# NOTICE OF DECISION

**HISTORIC DESIGN REVIEW CASE NO.:** HIS20-31

**SUMMARY:** A proposal to install signage on the exterior of the Reed Opera House.

**HISTORIC DESIGN REVIEW CASE NO. HIS20-31  
DECISION**

**EXHIBIT F**

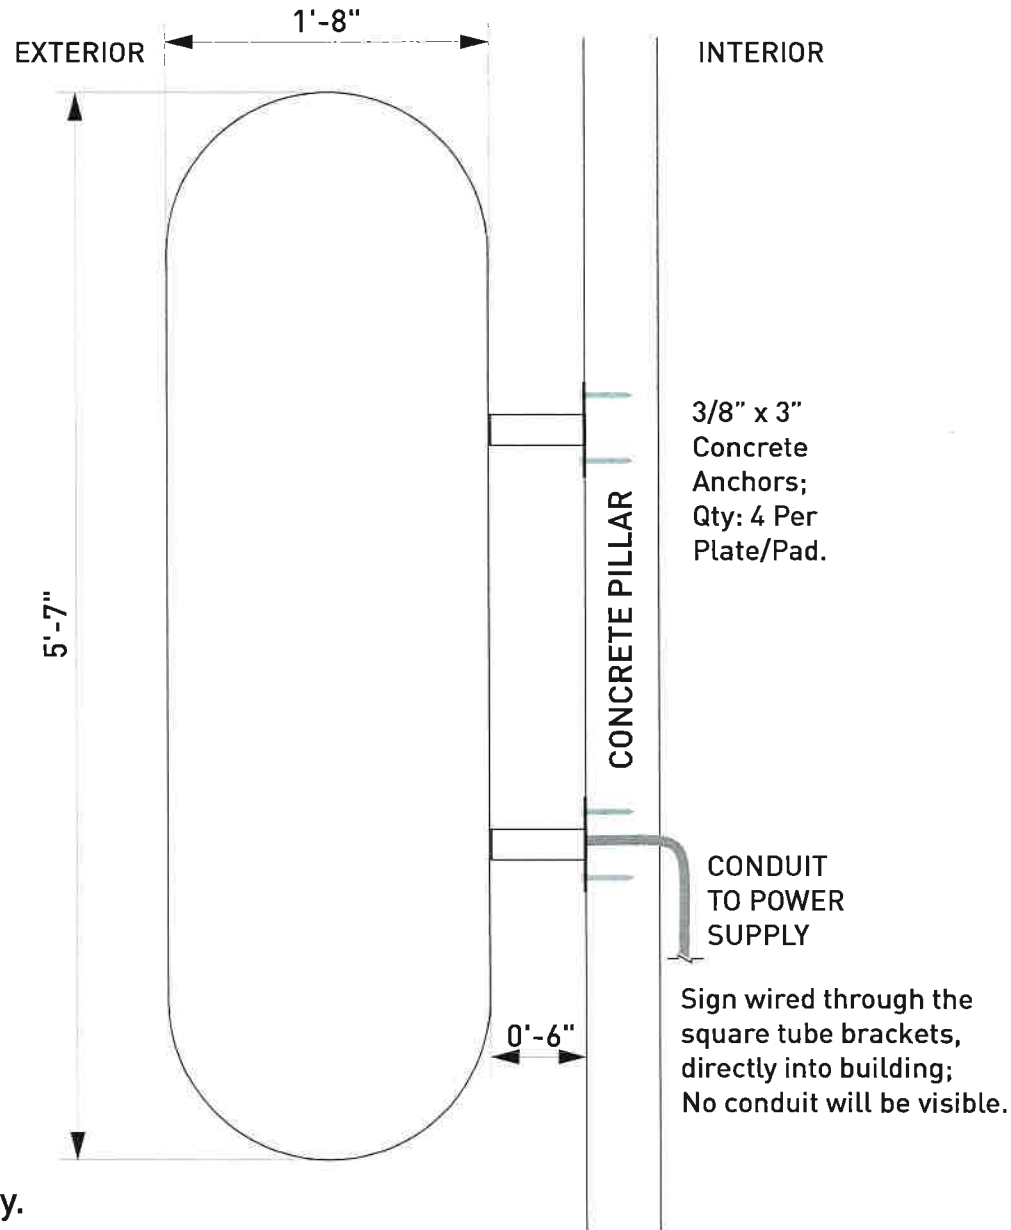
**Finding:** The applicant's proposed illuminated signage (3 projecting signs) all have conduit which will be wired through the square tube brackets directly into the building per Exhibit F in **Attachment B**. No conduit will be visible therefore staff finds that this standard has been met.
